From: Shawn Brosnan <shawn.brosnan@formiga1.com>
Sent: Thursday, 20 April 2023 9:35 PM
To: Callum Bell
Cc: 22066 McNab - Rockpool Pelican Waters; Ashley Lowe; Adrian Wyatt; Craig Gillard; Michael Hemmings
Subject: Re: Rockpool Pelican - Loading bay Exit Door FRL RFI

From: Callum Bell <Callum.Bell@mcnab.net.au>
Sent: Tuesday, April 18, 2023 3:14 PM
To: Michael Hemmings <michael@gjgarchitects.com.au>
Cc: 22066 McNab - Rockpool Pelican Waters <mailbox.22066@mcnab.net.au>; Ashley Lowe <Ashley.Lowe@mcnab.net.au>; Adrian Wyatt <Adrian.Wyatt@mcnab.net.au>; Craig Gillard <craig@gjgarchitects.com.au>
Subject: Rockpool Pelican - Loading bay Exit Door FRL

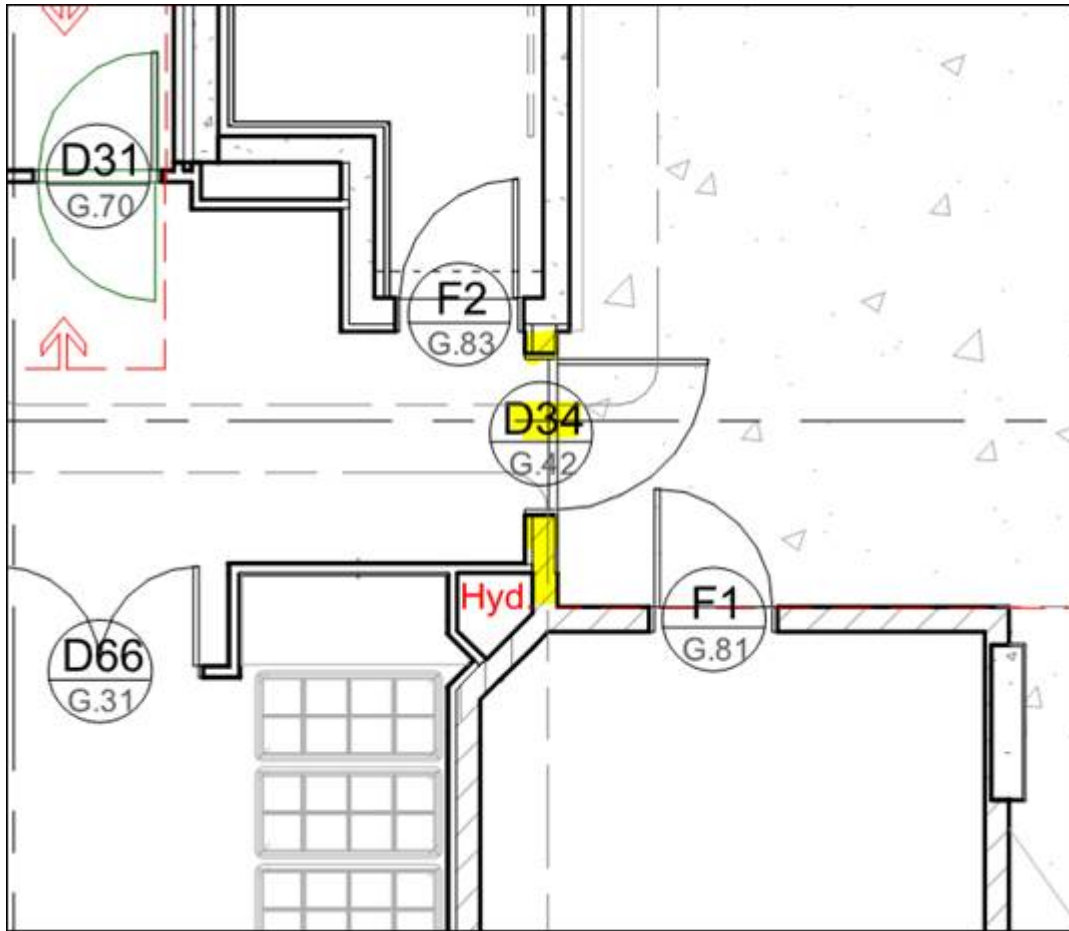
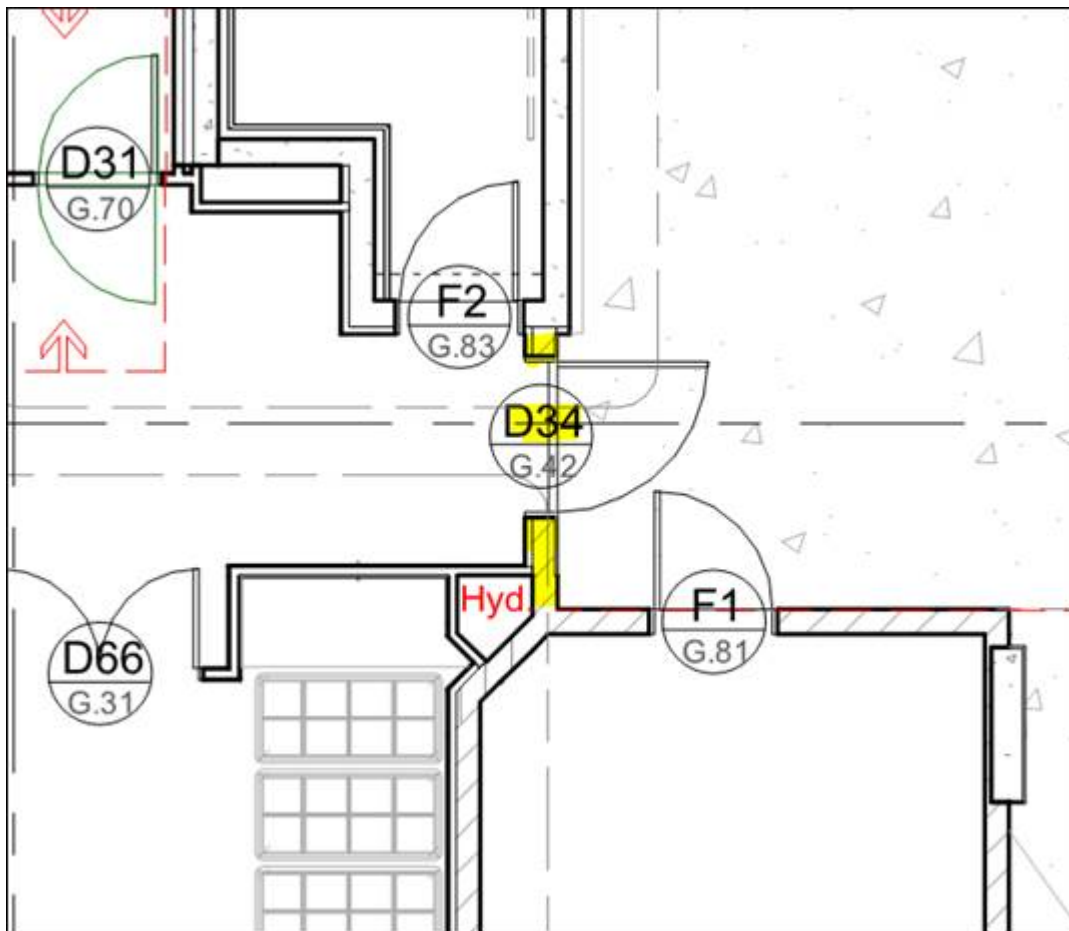
We have a query regarding the door and wall which forms the junction of the internal back of house area and the loading bay.

Our take it the D34 door does not need to be fire rated, and however we are unsure on the surrounding wall. The wall itself has an FRL but we believe this is inherit in the structural requirements.

We have services running through this wall (above the door) and are unsure if these need to have passive fire treatment, smoke treatment, or none at all (other than vermin / weatherproofing).

Can you confirm that if services are passing through this wall (above the door) what treatment do they require?

I believe this was raised back during the design stage but id like to confirm if the Loading bay door (D34) and wall requires a fire rating?

Can you please confirm as the door and frame installed is currently not fire rated, and there are mechanical services above the door which may / may not need passive fire treatment.

As the Ground floor has been included in the FER to allow it to be a single fire/smoke compartment, there is no requirement for this wall to be anything other than a 120/-/- FRL to support the floor and building over.

As such the door and penetrations in this area as questioned do not require an FRL level.

Please ensure the Structural Engineer can confirm the penetrations do not affect the structural FRL design of the wall.

I am not aware of any reason for this door to be fire rated.

Compartmentation Plan – no fire rating line at the Exit door location.

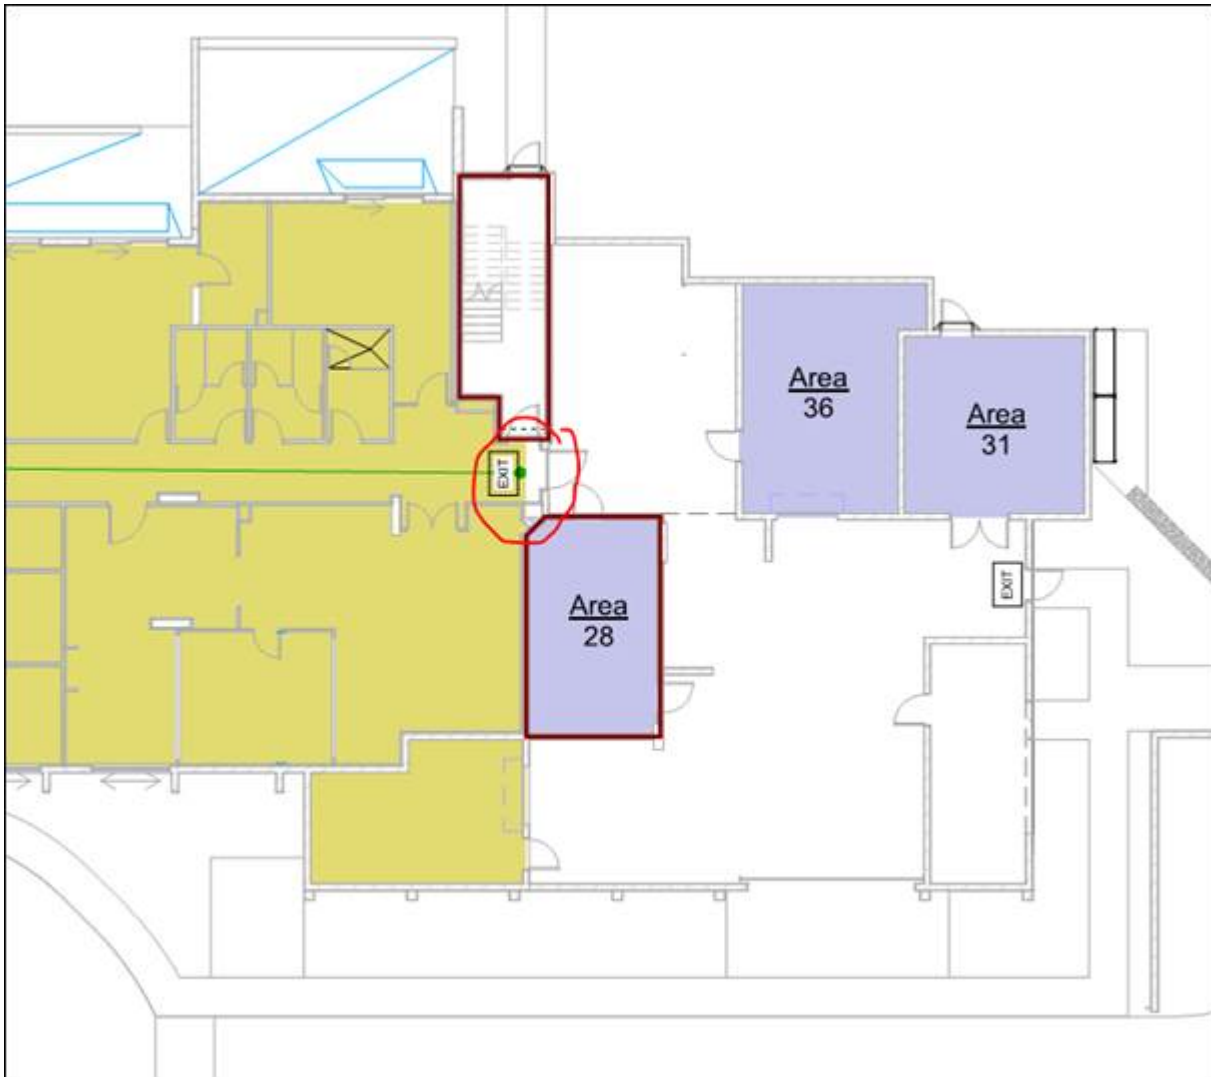
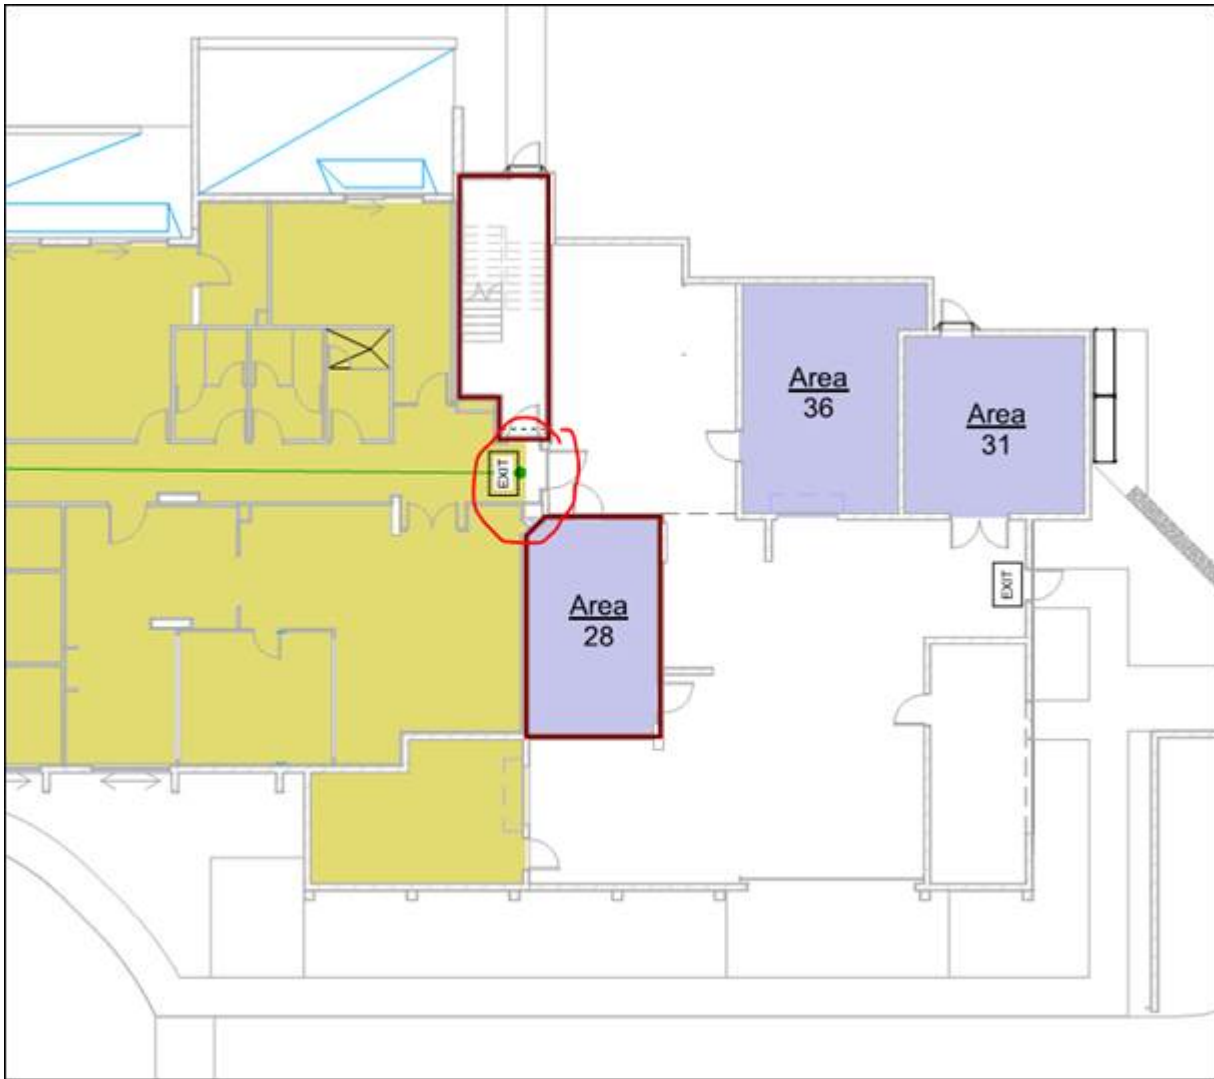
With the compartmentation plan, are we interpreting this correctly as being the end of the internal compartment and therefore needs Fire rating?

Compartmentation Plan – no fire rating line at the Exit door location.

Wall types plan and legend calls up FRL:

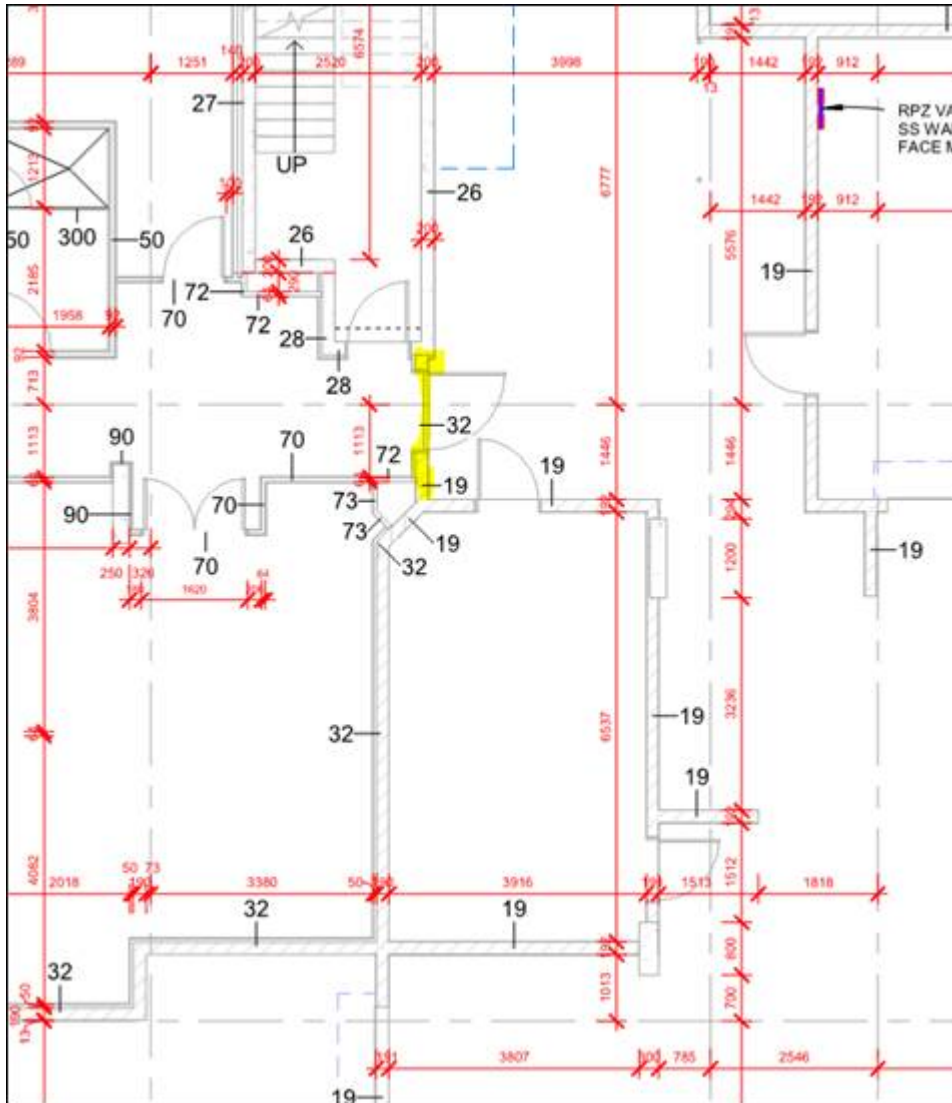
Is the wall itself considered a fire wall? The wall types calls it up as 32, which has an FRL, however is this just for the wall portion that is the Switchboard room.

The door itself is called up a standard door in the Door schedule, however the Wall Types drawing has wall type 32 with an FRL.

It would need a structural fire resistance if it is part of the structure of the building. Other than that it shouldn't need one as I see it.
